THE MARYLAND-NATIONAL CAPITAL PARK AND PLANNING COMMISSION

MEMORANDUM

Preliminary Plan Review

Harry M. Martins Tract

| Vicinity and Neighborhood Delineation Map | 4 and 5 |
|---|---------|
| Proposed Resubdivision Plan | 7 |

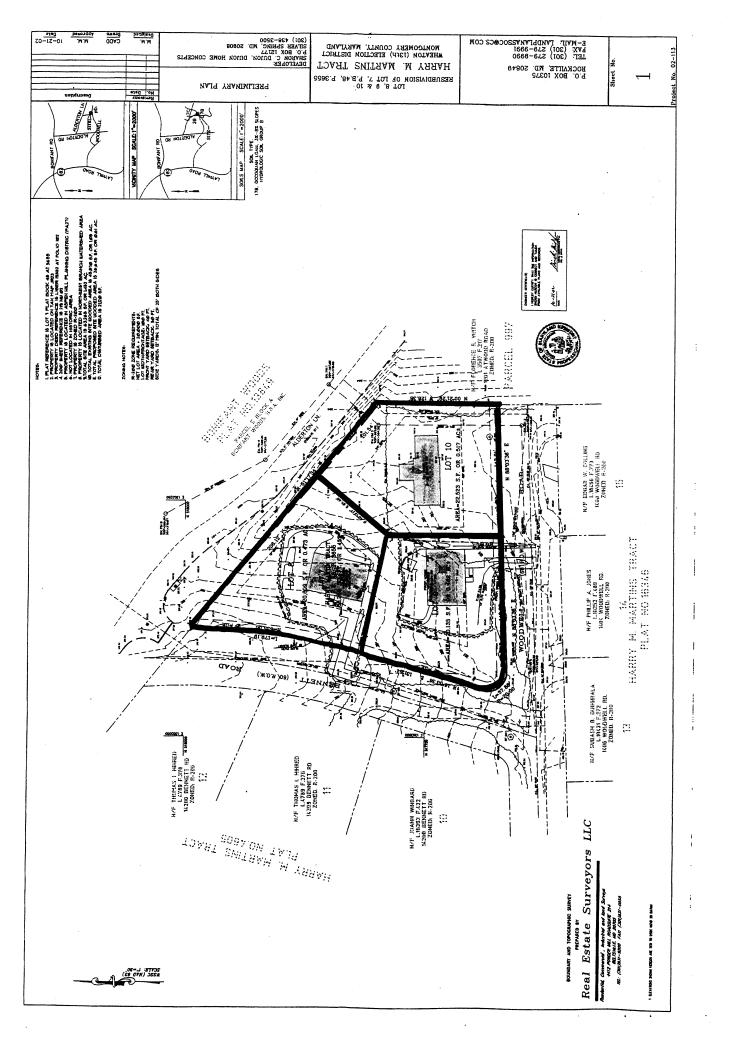
This application for resubdivision proposes to create three lots from Lot 7, of the Harry M. Martin Tract. The three proposed lots would range in size from 20,133 square feet to 22,523 square feet or approximately one-half acre in size. Proposed Lot 10 will be irregularly shaped, the other two lots will be somewhat rectangular to square. Frontages for the three proposed lots will range from 140 to 155 feet and area of the lots range from 5,600 square feet for Lot 9 to 12,175 square feet for Lot 8. All proposed lots are aligned perpendicular to the street and are suitable for development.

In applying the resubdivision criteria to the analysis area delineated by staff, staff concludes that the proposed resubdivision does not satisfy all seven of the criteria set forth in Section 50-29(b)(2) as illustrated by the characteristics set forth on the attached tabular summary. Based on the lot pattern within the defined neighborhood, staff finds that this resubdivision is not consistent with the neighborhood characteristics. Specifically, staff finds that the proposed lots do not meet the size and area criteria. Further staff has reservations about the shape of proposed Lot 10, in that its irregular shape is not found elsewhere in the neighborhood. Since this proposal fails three of the seven resubdivision criteria, staff concludes that this application for three lots should be denied.
